## STAFF REPORT COMMUNITY DEVELOPMENT DEPARTMENT

HEARING DATE: 7/21/2020  
 TO: Mayor & City Council  
 FROM: Alan Tiefenbach, Associate Planner  
 208-489-0573  
 SUBJECT: PP-H-2020-0025  
 Chukar Ridge  
 LOCATION: The site is located at 4005 N. McDermott Rd., in the NE ¼ of Section 32, Township 4 N., Range 1W.

Preliminary plat consisting of 63 buildable lots, 8 common lots and 5 other lots on 15.42 acres of land in the R-8 zoning district.

## A. Plat (date ~~2/20/2020~~ 7/2/2020)

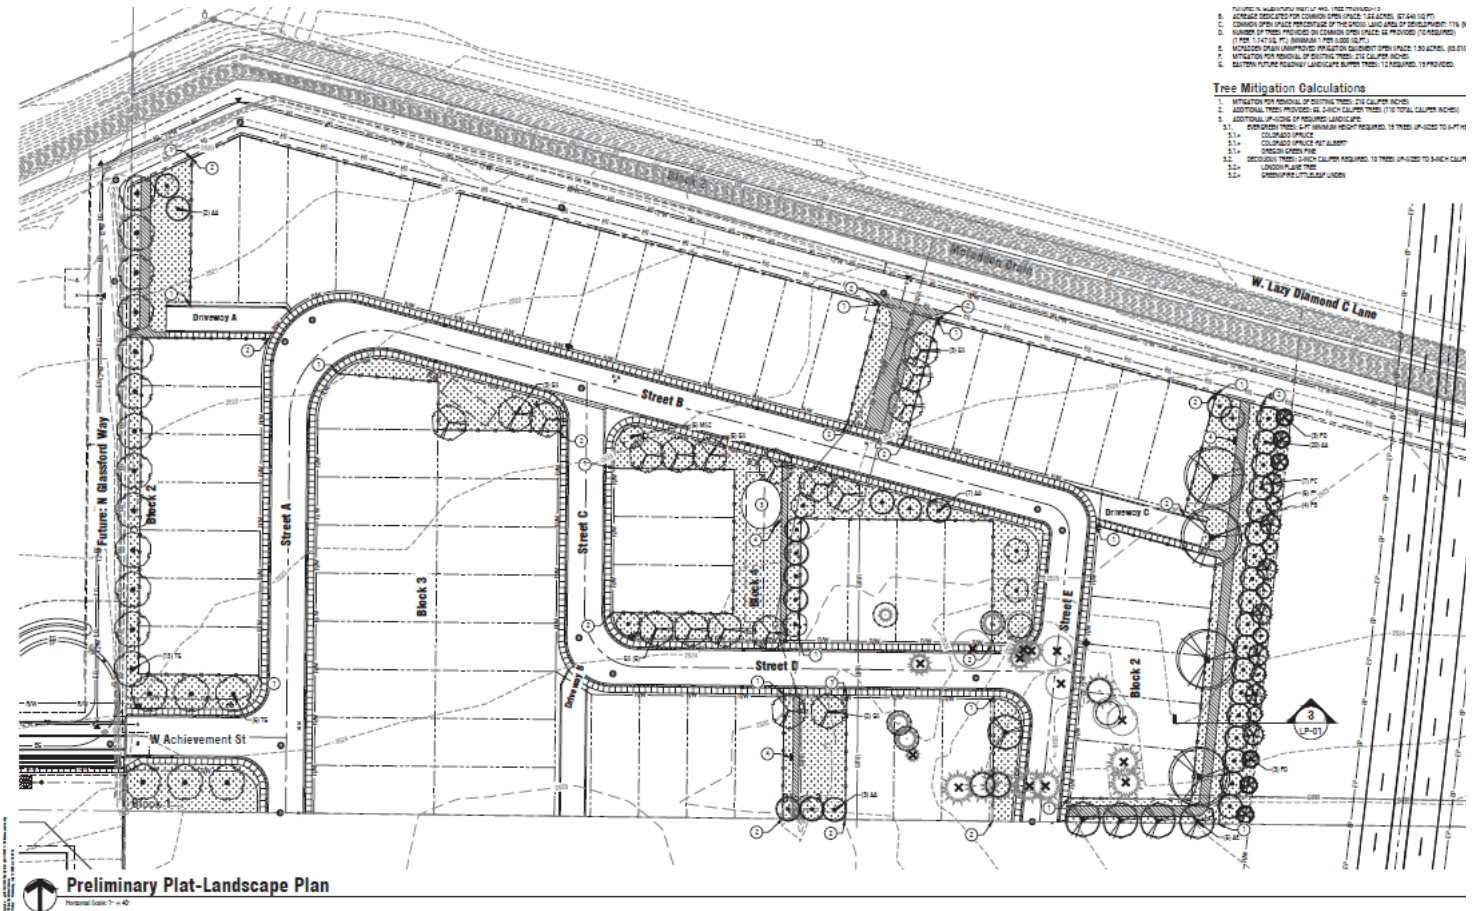
*UDC 11-6C-3 prohibits lots with double frontages. This type of road configuration is shown along Lots 1-10 of Block 2. Staff recommends a condition that the plat and landscape plan be revised to incorporate a 10' wide buffer in a common lot between the future north / south local street and Lots 1-10 Block 2. NOTE: The City has approved the second phase of the Gander Creek South Subdivisions. This phase does include a stub street in a location that will be extended when the elementary school is developed west of this property. Timing for the extension of this roadway is unknown at this time.*

- a. Commissioners discussed whether they were comfortable moving forward on this application without ACHD hearing and staff report. At least one Commissioner recommended a continuance. ACHD has since responded in favor of this application, with a condition that the applicant dedicate right of way and improve McDermott Road abutting the site as ½ of a 46-foot wide street section with curb, gutter and no sidewalk. The applicant is amenable to this and has revised the plat accordingly.

- b. Commission discussed the shared drives and their concerns with more than three homes sharing a common driveway. Applicant has revised the drawings limiting the homes on the shared drives to three.

1. The preliminary plat, dated ~~2/20/2020~~ 07/2/2020, shall be revised as follows:
  - a. Lot 40, Block 2 shall be restricted to development and reserved for the future expansion of State Highway 16.
  - b. ~~No more than 30 homes shall be constructed unless a permanent secondary emergency access is established.~~ No more than 30 homes shall be constructed unless one of the following is completed:

B.1 Landscape Plan (date: ~~2/20/2020~~ 7/15/2020)

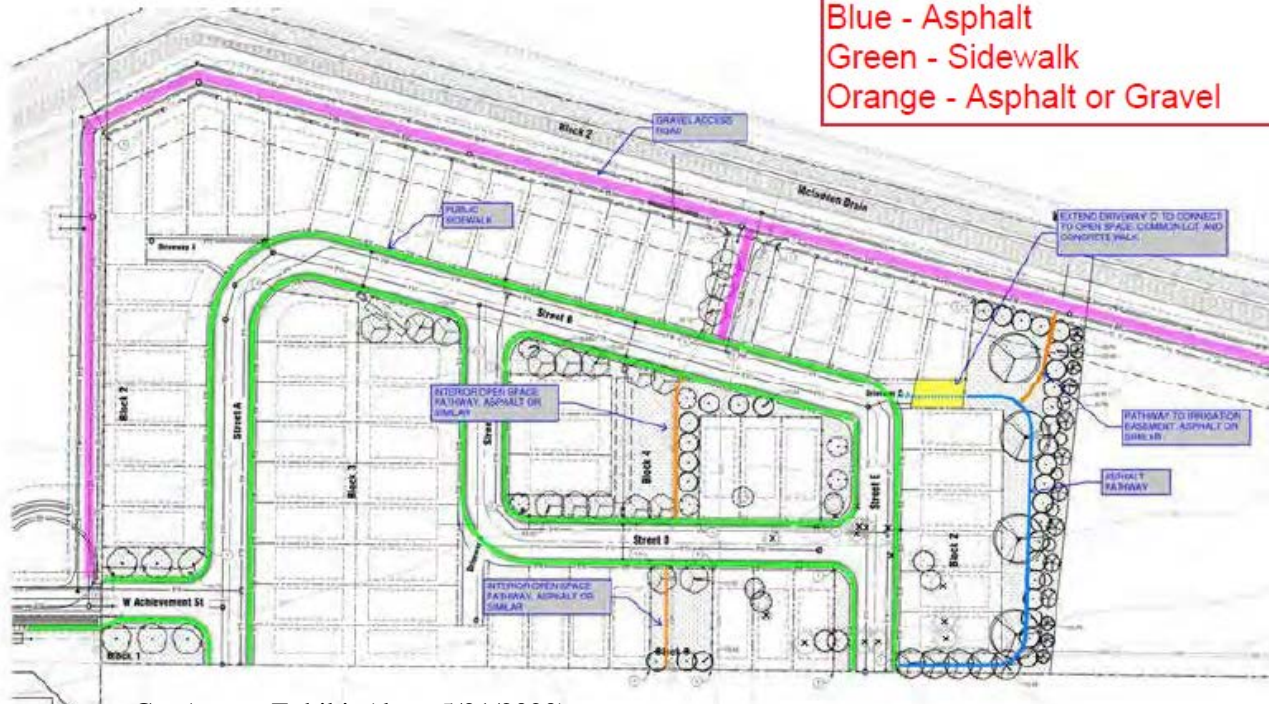
- e. Commission discussed whether the amenities provided accommodated children. Commissioner Grove recommended an amenity to address this. Applicant agreed to provide a "tot lot" as an additional amenity. The landscape plan has been updated accordingly.

- f. Commissioner discussed the 6' height of the sound wall and whether it could be raised. They mentioned they would like to see it higher, and tie into the same type of berm and wall approved for the Gander Creek Subdivision to the south. The applicant is amenable to this and has provided a detail on the landscape plan showing a 6' berm and 6' wall.

2. The landscape plan included in Section VII.C, dated ~~02/31/2020~~ 7/15/2020, shall be revised as follows: ~~10 days prior to submittal of the City Council:~~

- c. The pathway connection – emergency access through Lot 25 will consist of a 20' gravel access drive, at least 10' of landscape area on either side and a 5' paved walkway.

B. Pathway Plan (date: 2/20/2020)

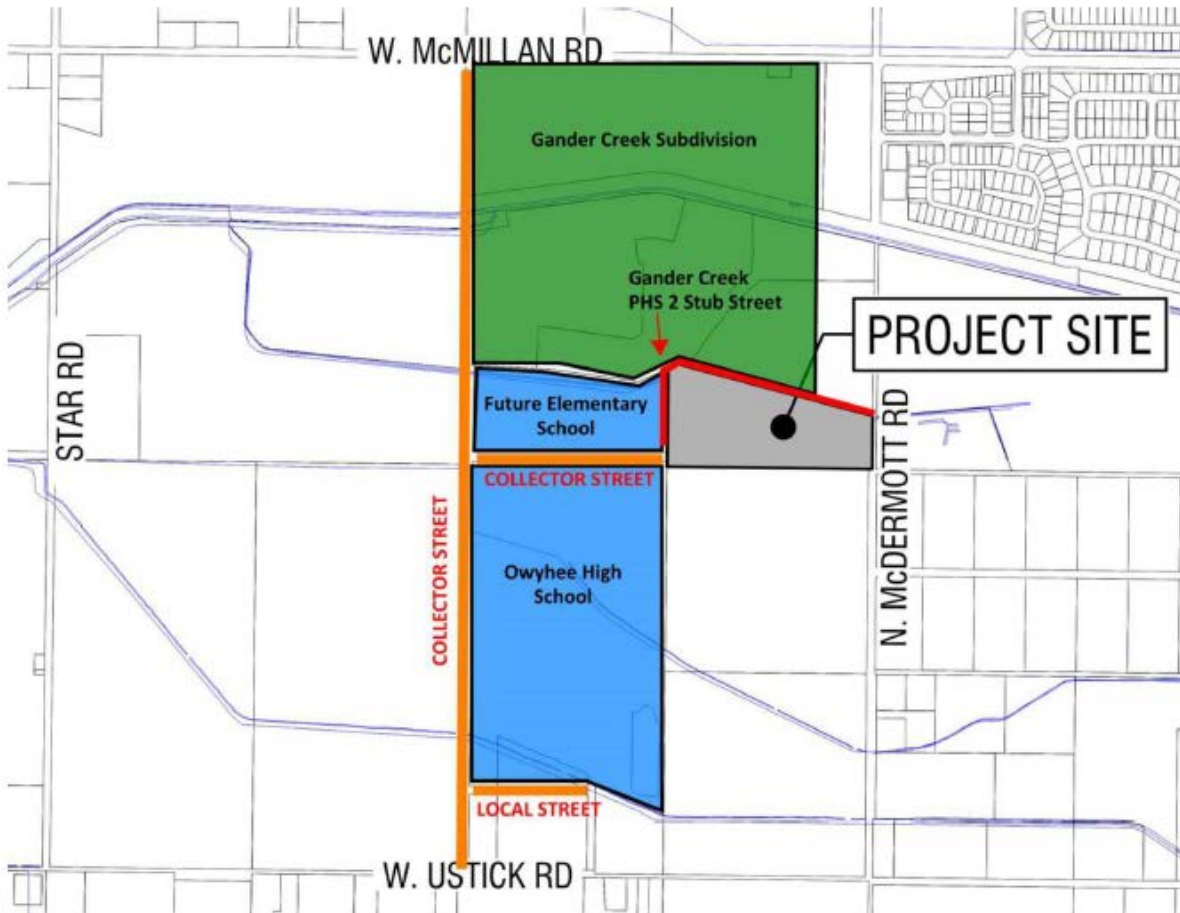
*The applicant proposes 54,032 square feet of qualified open space, or 10.2%. The majority of this qualified open space comprises a walkway loop and passive recreation area with an approximately 16,500 square foot open space area at the center of the development (please see the conceptual pathway plan). Landscaping will surround a paved trail on the south side of Lot 37 and the length of Block 2 (east perimeter). This open area will connect to the McFadden Drain (which must remain gravel), then the pathway will return south through the center of the development.*

*The landscaping as proposed meets the minimum requirements of 11-3B but it is not reflected on either the preliminary landscape plan or open space exhibits whether any additional amenities such as benches or outdoor seating areas are proposed. Also, the conceptual pathway plan evolved from discussions with staff and the applicant late in the design process. The applicant understands the landscape plan must be revised 10 days prior to City Council to indicate the pathway alignment, type and design of construction, any outdoor seating, and other passive recreation areas. This landscape plan should clearly indicate Lot 25, Block 2, which is both providing emergency access out the McFadden Drain and serving as a walkway to the loop system, to contain landscape strips of a minimum of 10’ wide on either side of the gravel access. These requirements have been added as a condition of approval.*

C. Access Exhibit (date: 5/21/2020)

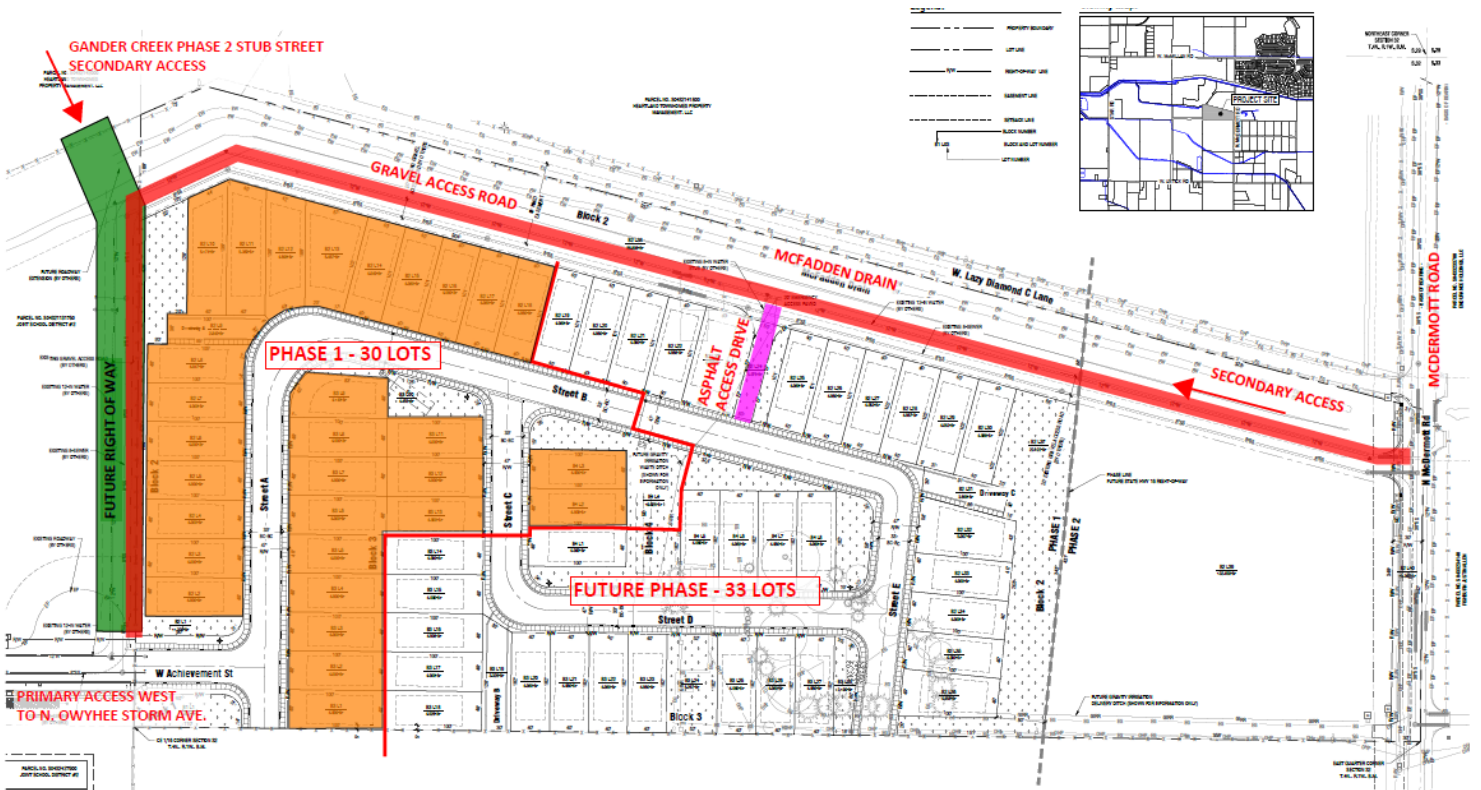
*The Chukar Ridge Subdivision is proposed to take access from three primary roads: W. McMillan Road, W. Ustick Road, and (temporarily) N. McDermott Road (see attached access exhibit). Access from W. Ustick and W. McMillan will occur from a north / south public collector roadway (shown in orange on the access exhibit) which would then connect to an east / west local street terminating into the development. The portion of the collector south of the subject property to W. Ustick Road is currently under construction and completion is anticipated this year. The portion of the public roadway north of the subject property to W. McMillan Road is required to be constructed as part of the Gander Creek Subdivision and construction is anticipated to be completed in late 2021. West Ada County Schools are constructing the east / west local street from the collector to the subject property per the 2019 Annexation Development Agreement (an elementary school is anticipated directly west of the subject property). Two stub streets are being provided with this development for any future build out of the property to the south, which is presently not in the City of Meridian limits.*

*No more than 30 lots can be served without a secondary access. There was a secondary emergency access proposed which would (temporarily) occur from the north through Common Lot 2, Block 2 and to a gravel road eastbound along a utility easement adjacent to the McFadden Drain and to N. McDermott Road. However, at some point, a Hwy 16 extension east of the property will be constructed. This would terminate eastbound emergency access along the McFadden Drain. As an alternative, the applicant proposes access westbound along the McFadden Drain and to a north / south collector road that is to be constructed as part of the Gander Creek Subdivision and W. Ada County Elementary School. Meridian Fire has reviewed this plan and agrees with the access. Staff does have concerns with allowing a subdivision of more than 30 homes to be constructed before secondary access is established. Staff recommends as a condition of approval that no more than 30 homes may be constructed without a permanent secondary access.*

F. Fire Phasing Exhibit (date: July 15, 2020)

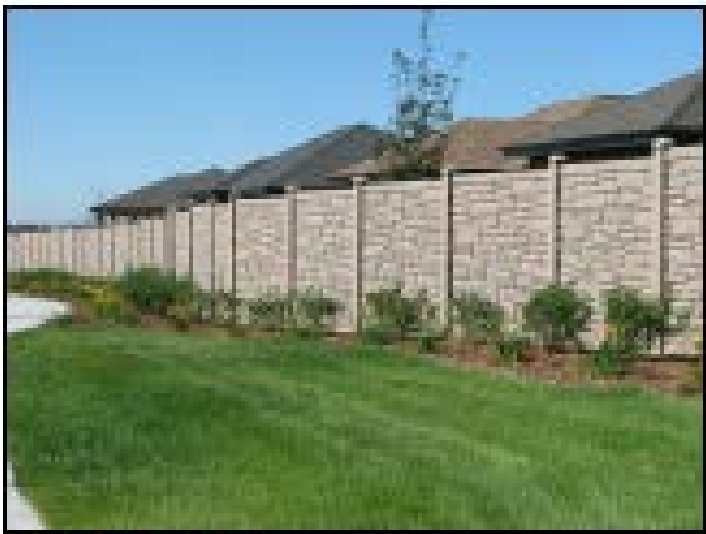
1. Summary of the City Council public hearing:
  - a. In favor: Matthew Adams, Applicant's Representative
  - b. In opposition: None
  - c. Commenting: None
  - d. Written testimony: None
  - e. Staff presenting application: Alan Tiefenbach
  - f. Other Staff commenting on application: None
2. Key issue(s) of public testimony:
  - a. None
3. Key issue(s) of discussion by City Council:
  - a. Discussion regarding allowing fire sprinkling to serve in lieu of requiring a second point of access if more than 30 homes were built.
4. City Council change(s) to Commission recommendation:
  - a. Changed staff's recommendation listed in VIII.A.1.b to read:  
"No more than 30 homes shall be constructed unless one of the following is completed:

Option A: Construct roadway crossing of the McFadden Drain to connect to Gander Creek South.

Option B: Construct connection south to Ustick Road.

Option C: Fire Sprinkle all structures in excess of 30 units (unit 31 through unit 63). “
